HISTORIC AND DESIGN REVIEW COMMISSION

April 05, 2017

HDRC CASE NO: 2017-121
ADDRESS: 8514 MISSION RD / STINSON MUNICIPAL AIRPORT
LEGAL DESCRIPTION: NCB 11175 BLK LOT NW IRR 862.87 FT OF TR 12 (ARB 12C)
ZONING: R-6
CITY COUNCIL DIST.: 3
DISTRICT: Mission Historic District
APPLICANT: Rodney Fontana/RVK Architects
OWNER: City of San Antonio
REQUEST:

Historic & Design Review Commission
Description of Work
Stinson Airport Monument and Directional Signs

EXISTING CONDITION AT
CORNER OF MISSION ROAD AND
99TH STREET

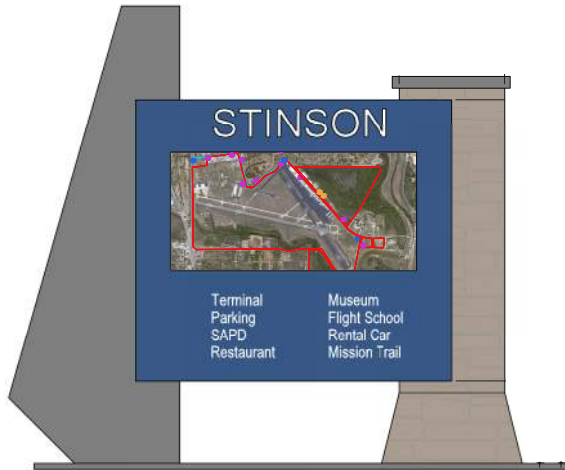
- b. **MONUMENT SIGNS** – At the intersection of Mission Road and 99th Street, Mission Road and Acequia and Roosevelt and 96th Street, the applicant has proposed monument signs to feature a combination of sandstone and aluminum panels to reflect the materials found throughout the airport property. The proposed sandstone will form a vertical column sitting on top of a low sandstone wall. On top of the low sandstone wall, the applicant has proposed to install aluminum panels which will feature signage to read "Stinson Municipal Airport". A low curved sandstone wall will surround the proposed monument signs to screen ground mounted lighting. The proposed total square footage for each is 102 square feet. Each sign will feature an overall height of twelve (12) feet with an overall length of approximately sixteen (16) feet. While the proposed signage exceeds the recommended fifty (50) square feet, staff finds that given the size of the proposed property in addition to the proposed design, that the proposed size and placement of the signage is appropriate.

Staff recommends approval as based on findings a through e with the stipulation that archaeological monitoring is required for all excavations near the intersection of Mission Road and 99th Street (Cadmus Street). The development project shall comply with all federal, state, and local laws, rules, and regulations regarding archaeology.

ELEVATION - DIRECTORY SIGN
1" = 1'-0"

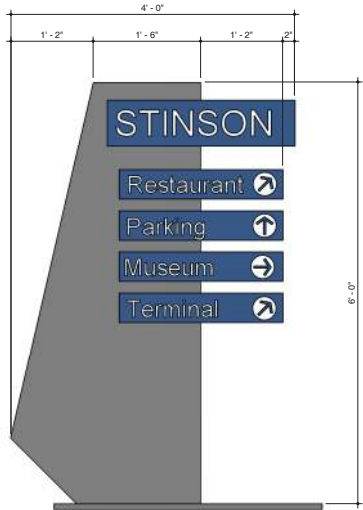
- c. **DIRECTORY SIGN** – At the parking and plaza area of the Terminal Building on the east side of Mission Road, the applicant has proposed to install a directional sign to feature both sandstone and aluminum, lettering consistent with that found on the Terminal Building and a map of the airport property highlighting points of interest and leaseholder locations. The map will be installed on an aluminum panel. This sign will feature an overall height of six (6) feet and an overall length of approximately seven (7) feet. Staff finds the proposed signage appropriate in regards to location, size and design.
